Hands-off detection

versus

Start of Lane Change Manoeuvre

LCM does not start

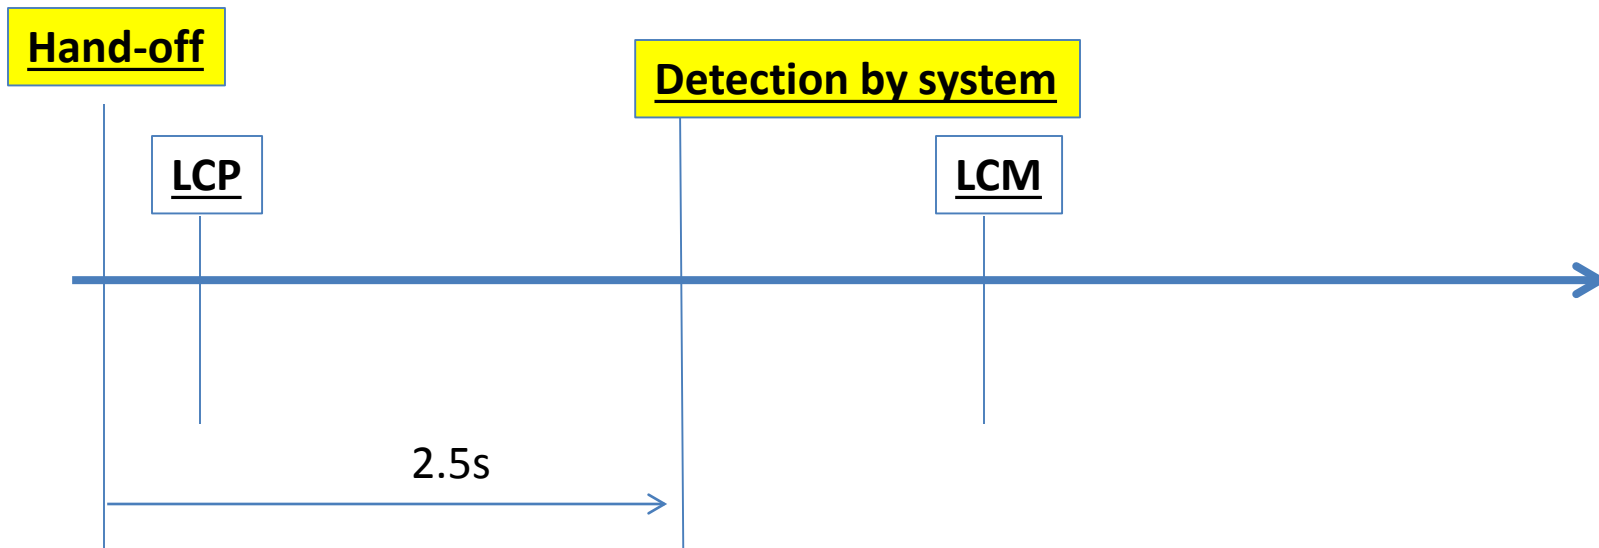
If, after a period of no longer than [3s] the driver is not holding the steering control, the system shall detect hands-off

According to CP proposal: « the system has not detected that the driver is holding the steering control at the start of the LCM »

Is it prohibited to start LCM or not?

LCM does not start

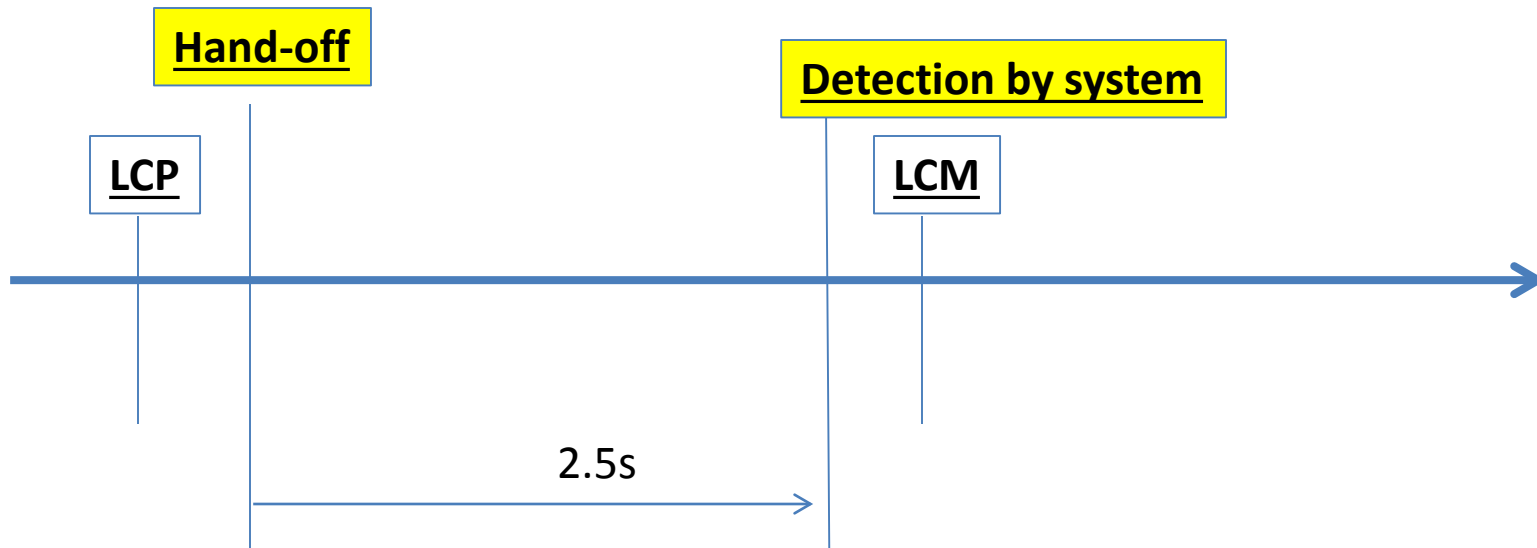
If, after a period of no longer than [3s] the driver is not holding the steering control, the system shall detect hands-off

According to CP proposal: « the system has not detected that the driver is holding the steering control at the start of the LCM »

Is it prohibited to start LCM or not?

LCM starts

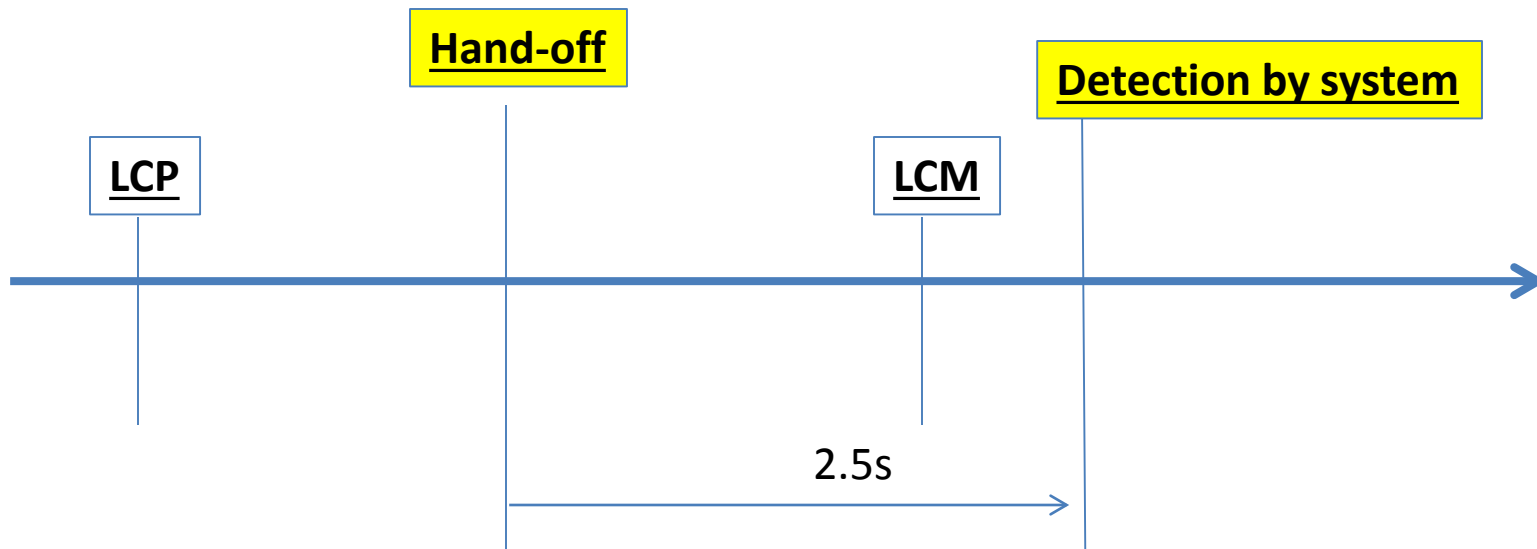
If, after a period of no longer than [3s] the driver is not holding the steering control, the system shall detect hands-off

According to CP proposal: « the system has not detected that the driver is holding the steering control at the start of the LCM »

Is it prohibited to start LCM or not?
